ADDENDUM NUMBER 1

- 1.01 DATE: April 7, 2015
- 1.02 PROJECT: Interior Renovations to the Mimosa - G Residence
Ramapo College of New Jersey
- 1.03 SNS PROJECT NUMBER: 4698G

INTERIOR RENOVATIONS
AT THE
MIMOSA - G RESIDENCE

Client

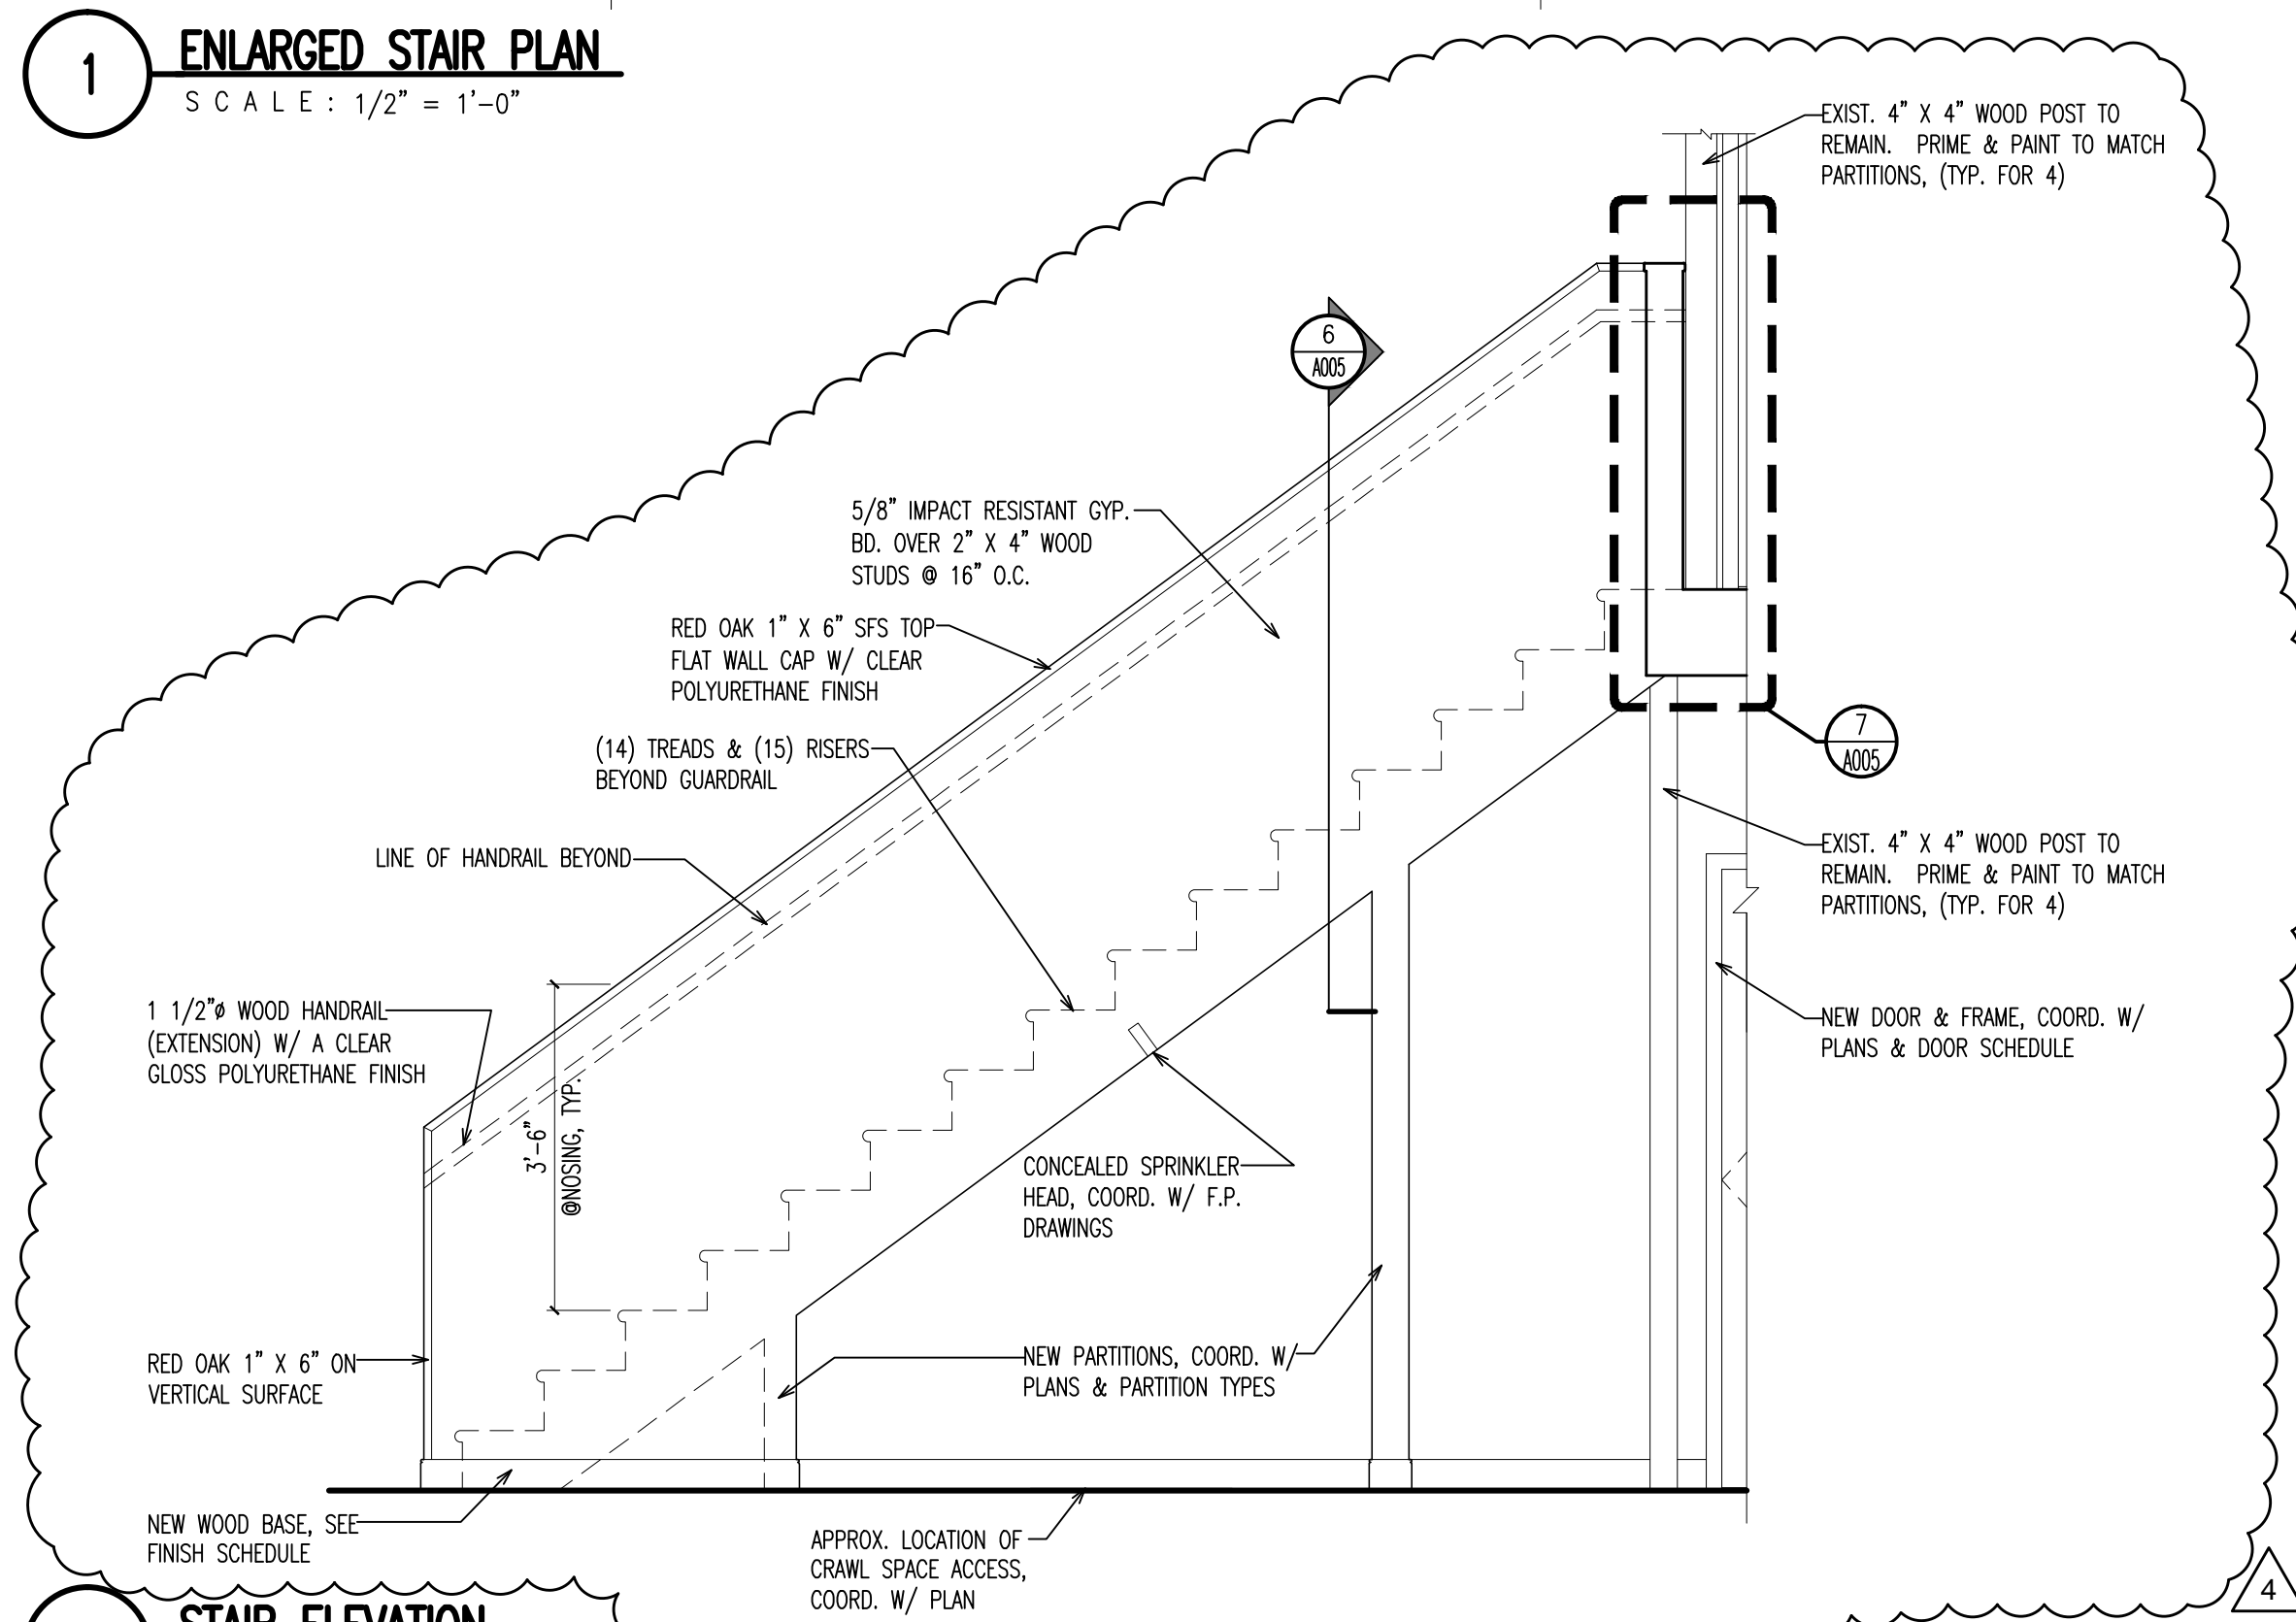
- 4.4. Insulation Notes: first note has been revised.
- 5. DRAWING A004, ENLARGED PLAN, MILLWORK, DETAILS & EQUIP. SCHEDULE:
 - 5.1. Equipment Schedule:

- 5.1.1. Mark & Description #29 have been removed (Vinyl Composite Tile Flooring).
 - 5.1.2. Mark #28, has been revised, it is no longer an alternate in kitchen area.

- 5.2. Enlarged Bathroom & Kitchen Plan: Mark #29 has been replaced with Mark #28.
 - 5.3. Cabinet Sections #7, #8 & Vanity Section #9: VCT finish flooring note has been replaced with” Linoleum finish flooring”.
